Amendments to the Drawings

REMARKS/ARGUMENTS

Fig. 3

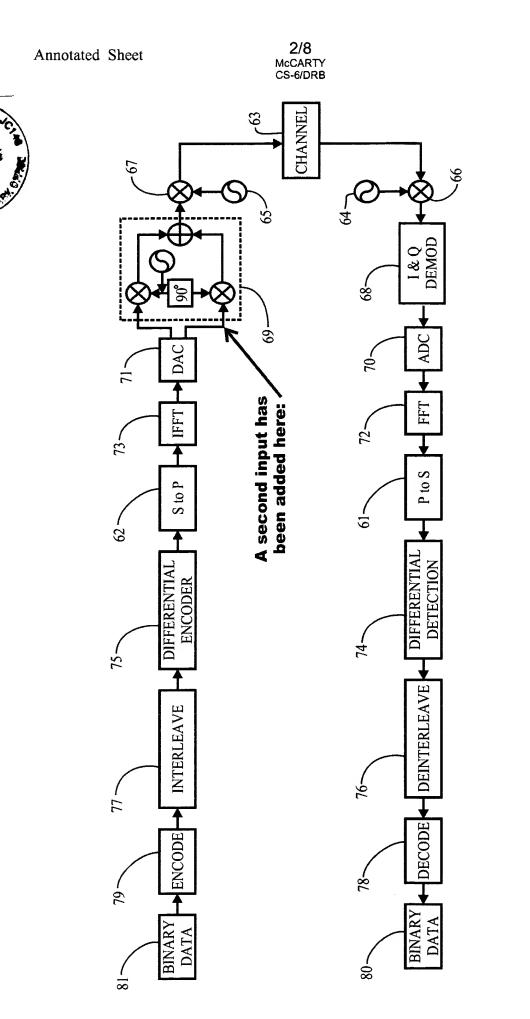
The attached sheet of drawings (2/8) includes changes to Fig. 3. This sheet, which includes Figure 3, replaces original drawing sheet 2 of 8. In Figure 3, a second input from DAC 71 to mixer 69 has been added.

Claims 1-10 are pending in the application. The drawings stand objected to because the modulator 69 in Figure 3 lacks a second input. The disclosure stands objected to because "FFT 73" in paragraph [23] should be "IFFT 73. Claims 1-10 stand objected to for various informalities in the language. Claims 1-10 stand rejected under 35 U.S.C. § 112, first paragraph, for failing to comply with the enablement requirement. Claims 4, 7, and 8 stand rejected under 35 U.S.C. § 112, second paragraph, as being indefinite for failing to particularly point out and distinctly claim the invention. Claims 9 and 10 stand rejected under 35 U.S.C. § 102(b) as being anticipated European patent number EP 0 991 237 A1 (Huber et al. "Huber"). Claims 1-8 would be allowable if rewritten to overcome the § 112 rejections and other objections noted above. Applicant is unaware of any other rejections or objections pending in the application.

Applicant has amended the drawings in accordance with the requirements of the Examiner's comments in the objection.
